**Re: Well #1 ([L131327](#)), 3,000-Gallon Tank, & NSF-55 Class B UV ([PR#84-2025](#))
Brooks Wine (PWS ID# [95761](#))
Conditional Approval**

Conditional Approval PR #84-2025 – 1 Well (L131327), 3,000-Gallon Tank, & NSF-55 Class B UV
July 25, 2025

Description of facilities reviewed under Plan Review #84-2025

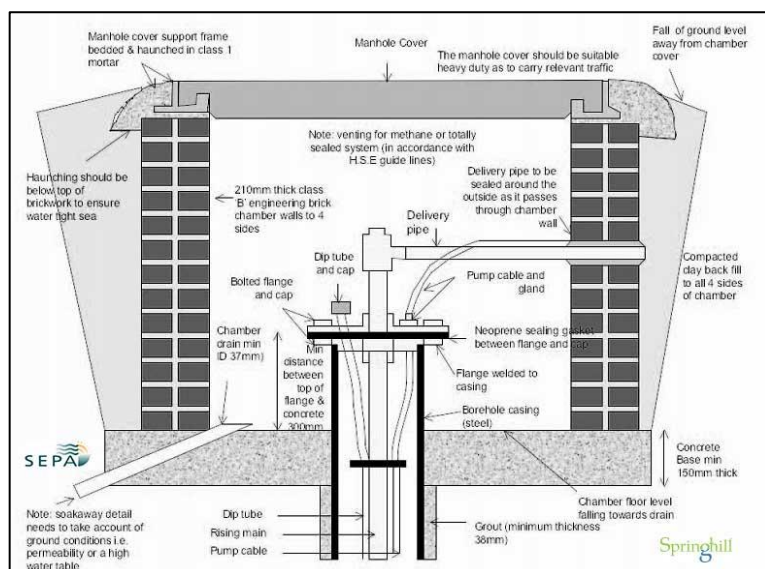
4. ☐ **The following sanitary hazards are not allowed within 100 feet of a well** which serves a public water system unless waived by the Authority: Any existing or proposed pit privy, subsurface sewage disposal drain field; cesspool; solid waste disposal site; pressure sewer line; buried fuel storage tank; animal yard, feedlot or animal waste storage; untreated storm water or gray water disposal; chemical (including solvents, pesticides and fertilizers) storage, usage or application; fuel transfer or storage; mineral resource extraction,

vehicle or machinery maintenance or long-term storage; junk/auto/scrap yard; cemetery; unapproved well; well that has not been properly abandoned or of unknown or suspect construction; source of pathogenic organisms or any other similar public health hazards.

No gravity sewer line or septic tank shall be permitted within 50 feet of a well which serves a public water system. Clearances greater than indicated above shall be provided when it is determined by the Authority that the aquifer sensitivity and degree of hazard require a greater degree of protection.

Above-ground fuel storage tanks provided for emergency water pumping equipment may be exempted from this requirement by the Authority provided that a secondary containment system is in place that will accommodate 110 percent of the fuel tank storage.

SRC-BA 1962 Well #2 (YAMH7105) - Unapproved (ca. 1/22/1962) - inactive

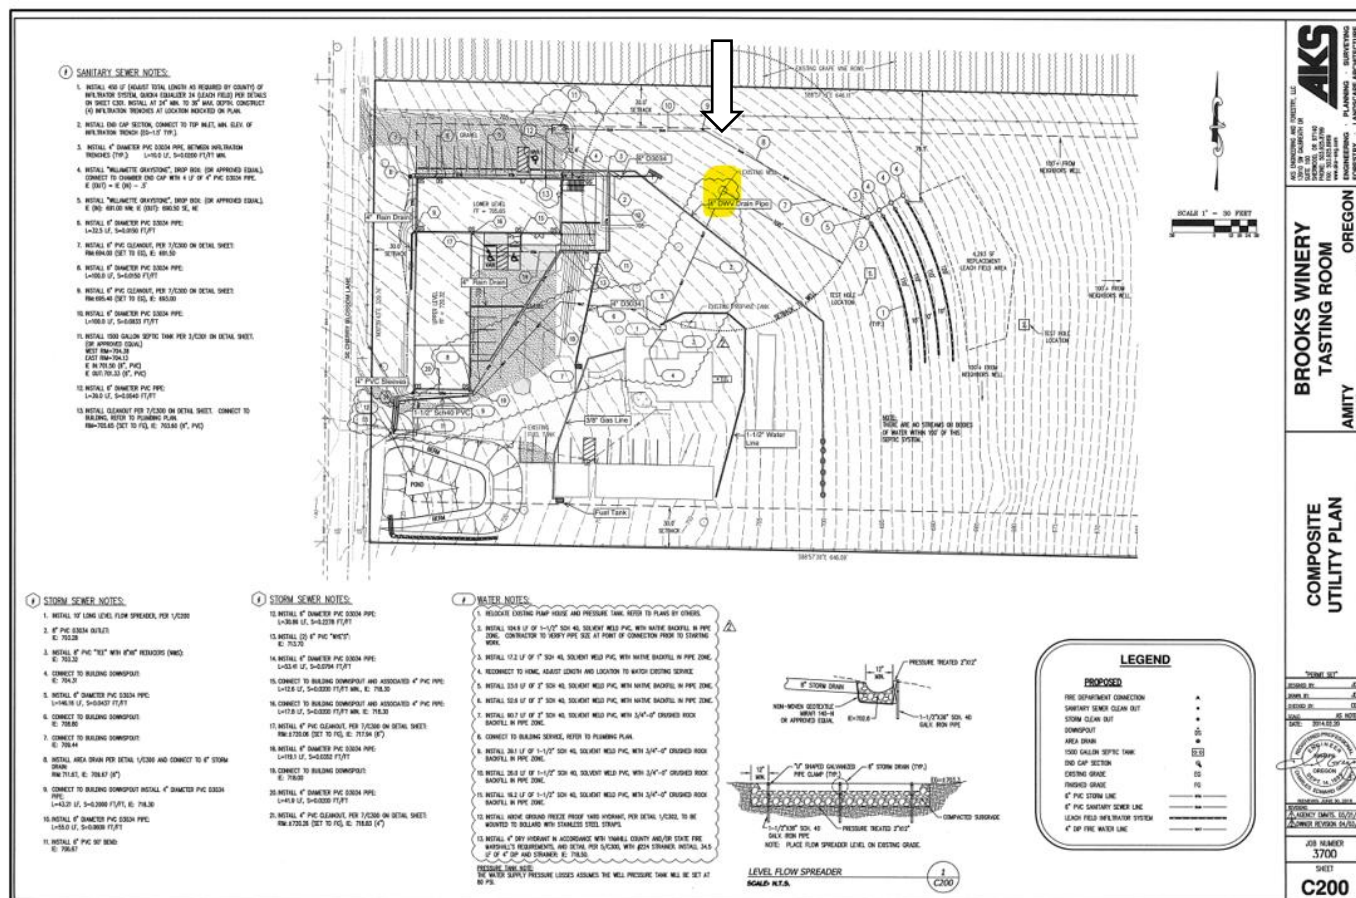
A second well (designated “SRC-BA 1962 Well #2 (YAMH7105) – Unapproved”) constructed 1/22/1962, ([YAMH7105](#)) was identified on the property, however this well was reported as being not in use (capped) and appears to be outside the 100-ft setback of the 2018 well (SRC-AA), therefore, it was inventoried in case it is placed into use in the future, **but not included in this plan review. You must ensure this well is not physically connected/piped to the existing drinking water system.**
